Pre-lodgement Meeting Notes

Application No: PLM2022/0219
Meeting Date: 31 January 2023
Property Address: 87 Blackbutts Road FRENCHS FOREST
Proposal: Construction of four senior's housing dwellings
Attendees for Council: Daniel Milliken - Manager, Development Assessments
Maxwell Duncan - Principal Planner
Adam Urbancic - Planner
James Brocklebank - Traffic Engineering Coordinator
Ray Creer - Waste Services Officer

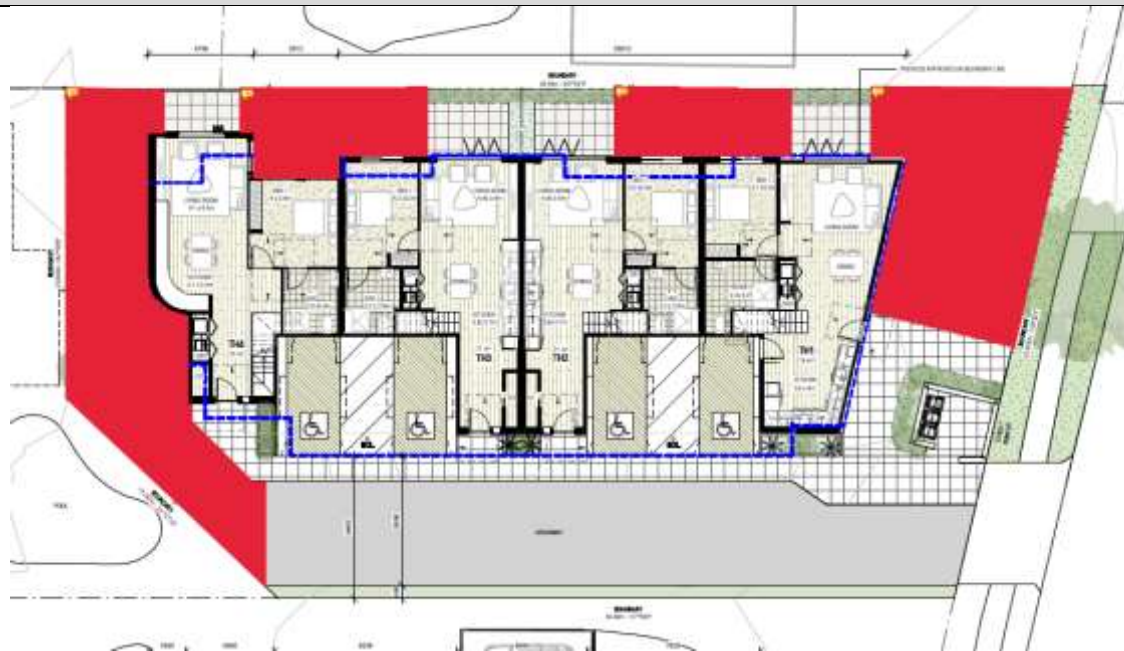
The driveway crossing is to be in accordance with Council's Vehicular Crossing normal profile which is available in Council's website. Any transitions to the driveway levels/gradients are to occur within the development site.
